Architectural Review Commission  
AGENDA

Monday, August 16, 2021, 5:00 p.m.

**PROJECT ADDRESS: 175 Venture (Main)**    **BY:** John Rickenbach, Contract Planner  
Phone Number: (805) 610-1109  
Email: JFRickenbach@aol.com

**FILE NUMBER: ARCH-0624-2020**                      **FROM:** Shawna Scott, Senior Planner

**Figure 7. Proposed Fence Height Exception**

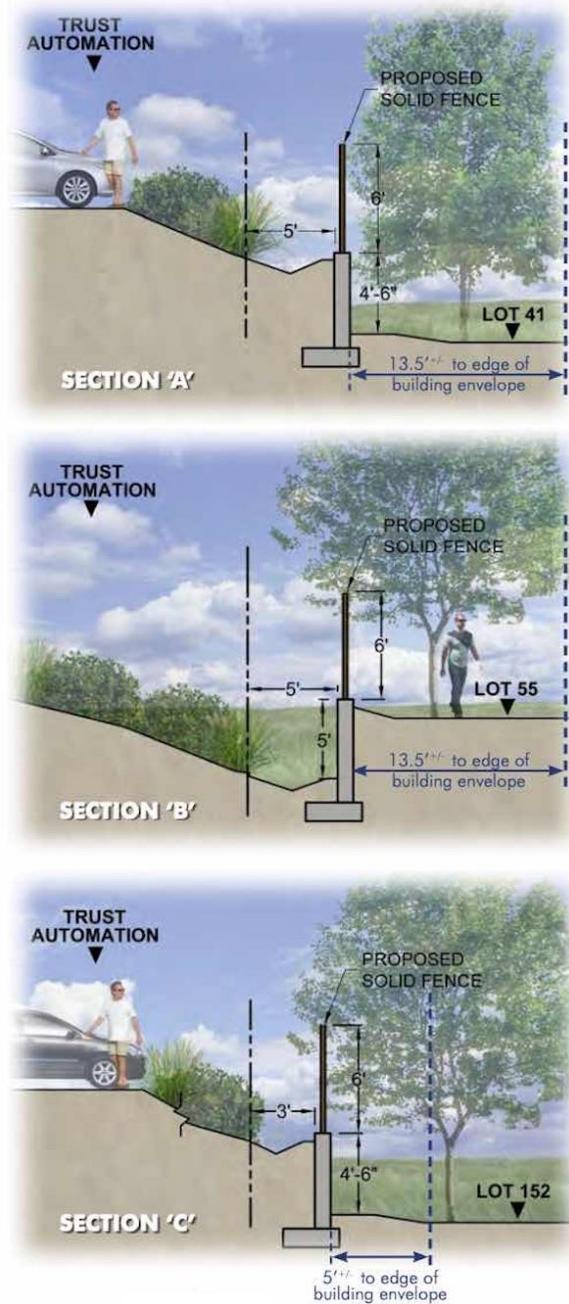
This exception is requested in response to the site topography and to provide privacy for proposed residential uses from the adjacent active industrial development, notably the parking areas near the property line. The majority of the retaining wall would face the residential development. The proposed fences would be located in the rear and side yards of the residential development and would not be visible along public roads.

See Figure 7 for the proposed fencing concept, which shows some of the detail from Sheet E1.0, included as Attachment 1. The site retaining walls were approved and permitted as part of Tract 3089 Phase 1 Improvements (FMAP-1563- 2018) and are included for graphic reference only to depict the total wall/fence height. The retaining wall varies in height from 2 to 7 feet. Although the combined height of the retaining wall and fence could be as high as 13 feet, because of topographic variation, in other areas it would be under 9 feet. Due to the tract drainage improvements, topography, and location of the approved walls, it is infeasible to offset the fence from the retaining wall.

**E1.0**

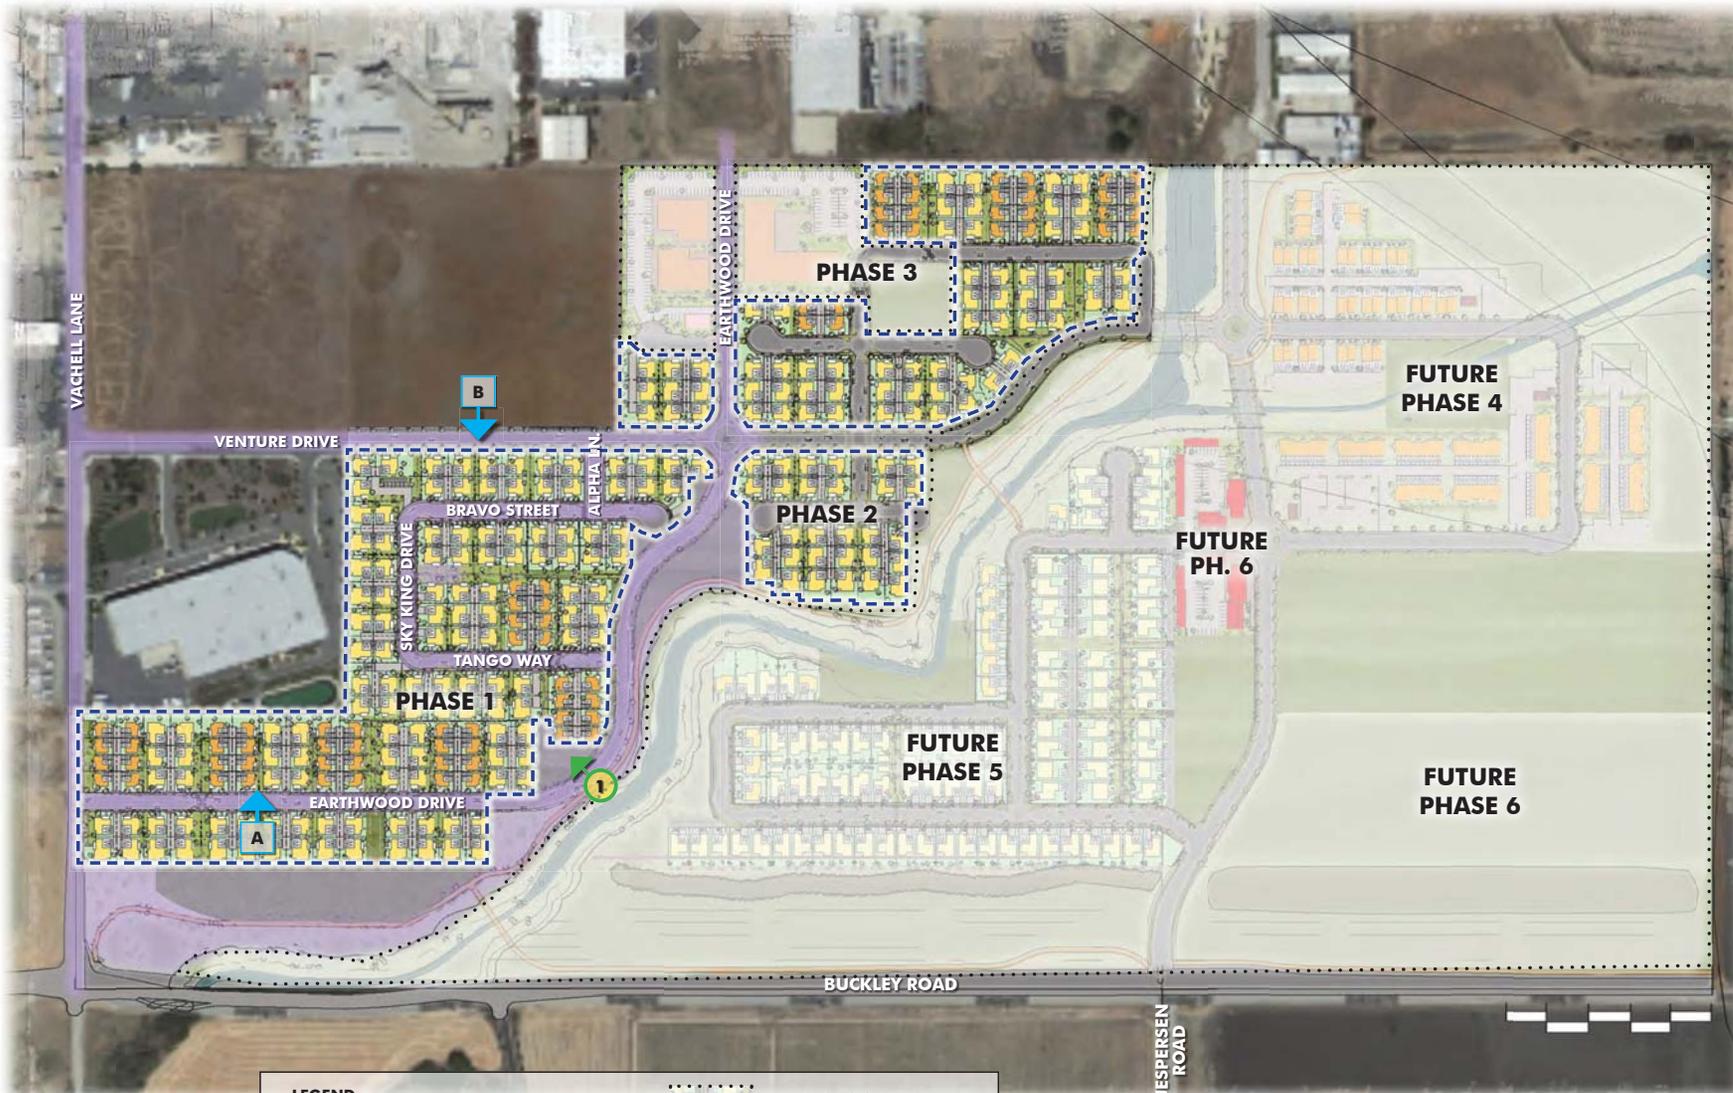
43. <u>Retaining wall and/or retaining wall/fence combinations along property lines</u> shall be approved to the satisfaction of the Planning Division and shall conform with the zoning regulations for allowed combined heights or shall be approved through the	See sheet EI.0 for details regarding the requested Fence/Wall Height exception for a maximum combined wall/fence height of 11 feet along the shared boundary with Trust Automation (APN 053-259-003).

MITIGATION MEASURE or CONDITION OF APPROVAL	CONFORMANCE COMMENT
ARC, Specific Plan, or separate Fence Height exception process.	Fence heights in all other areas of the development area are consistent with the Zoning Regulations.
